Technical Support Document for Louisiana Regional Haze: CALPUFF Best Available Retrofit Technology Modeling Review

(CALPUFF Modeling TSD)

Michael Feldman
Erik Snyder
April 2017

Figure 3-1. Map of BART-eligible EGUs for Model Plant analysis

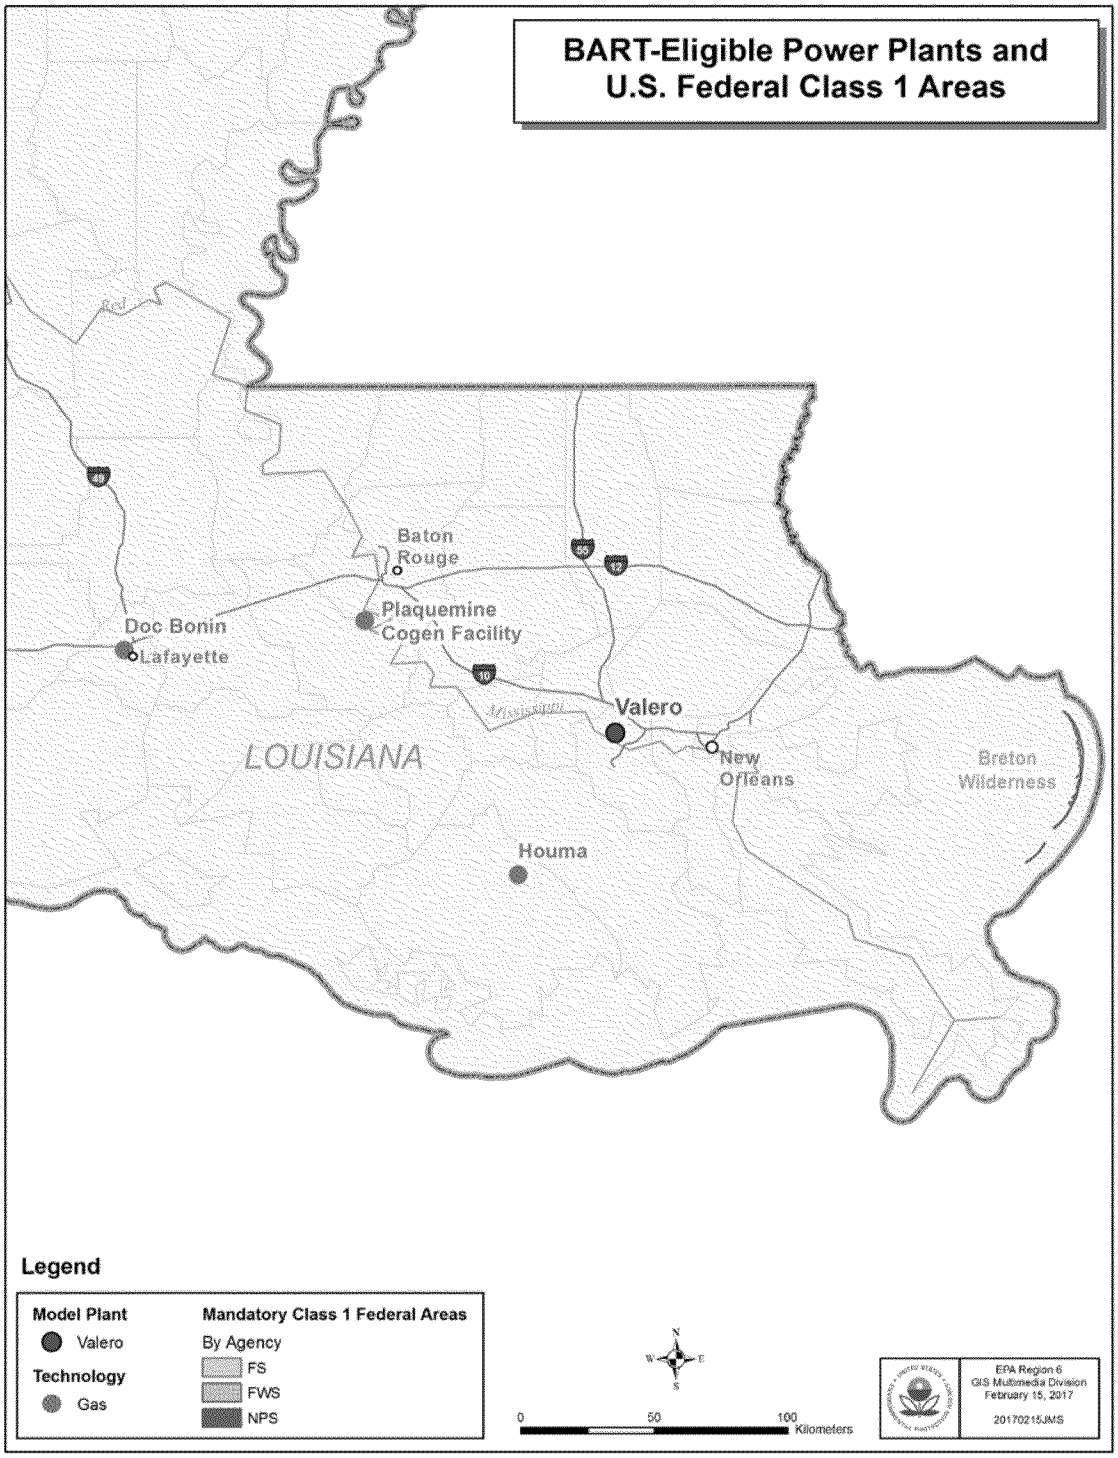
Houma and Plaquemine are both further from Breton than Valero and oriented such that transport winds are similar for all three facilities towards Breton. Plaquemine is upwind of Valero when transport patterns would carry emissions to Breton. Houma is located in the same general direction from Breton with similar transport conditions (winds from the west) transporting pollutants from Houma and Valero towards Breton. See the figure below for a map showing the location of the sources and the model plant. The Valero plant has higher emissions of SO2, NOx and PM than the Houma and Plaquemine sources. The Valero plant is also representative (similar stack height and parameters)[43] of the Houma and Plaquemine sources and can therefore be relied on in a more specific model plant analysis to demonstrate that, based on baseline emissions and distance to the Class I area, the Houma and Plaquemine sources are not anticipated to cause or contribute to visibility impairment at Breton and are therefore not subject to BART.[44] We analyzed the ratio of visibility impairing pollutants, denoted as 'Q' (NOx, SO_2, and PM-10 in tons/year)[45] to the distance, denoted as 'D' (distance of source to Breton in km). For example, if two sources were similar but one has a lower Q/D value, the lower ratio value (either due to lower emissions and/or greater distance) would be expected to have smaller visibility impacts at Breton. The Q/D ratio for Houma and Plaquemine are significantly lower compared to Valero's ratio (See Table 3 below). The Q/D ratios of Houma are approximately 20% of Valero's, and Plaquemine's ratio is less than 10% of Valero's Q/D ratio, and modeled impacts of the Valero source were less than the 0.5 dv

For our model plant comparison, Doc Bonin is further away from Breton than Valero but located in an area that sees similar wind transport to Breton. Doc Bonin has similar stacks and parameters[47] compared to the Valero sources. Overall emissions are similar, but Valero has more SO2 and slightly less NOx than Doc Bonin. We consider Valero to be conservative in terms of emissions of SO2 and NOx since SO2 yields much more visibility impairment in this region than NOx. With these factors being similar or conservative we analyze the Q/D ratios for the two facilities. The Q/D ratio for Louis "Doc" Bonin is significantly lower compared to Valero's Q/D ratio (See Table 3 below). The ratio is less than 40% of Valero's ratio and modeled impacts of the Valero source were less than the 0.5 dv threshold, which demonstrates that visibility impairment from the BART-eligible units at Louis "Doc" Bonin are reasonably anticipated to be less than the modeled impacts from Valero and below the 0.5 dv threshold to screen out. The model plant analysis demonstrates that, based on baseline emissions, the source is not anticipated to cause or contribute to visibility impairment of any Class I area, and is therefore not subject to BART. See the CALPUFF Modeling TSD for additional discussion of the model plant analysis. Because the modeling results demonstrate that Louis "Doc" Bonin is not subject to BART, we propose to approve this portion of the 2017 Louisiana Regional Haze SIP.
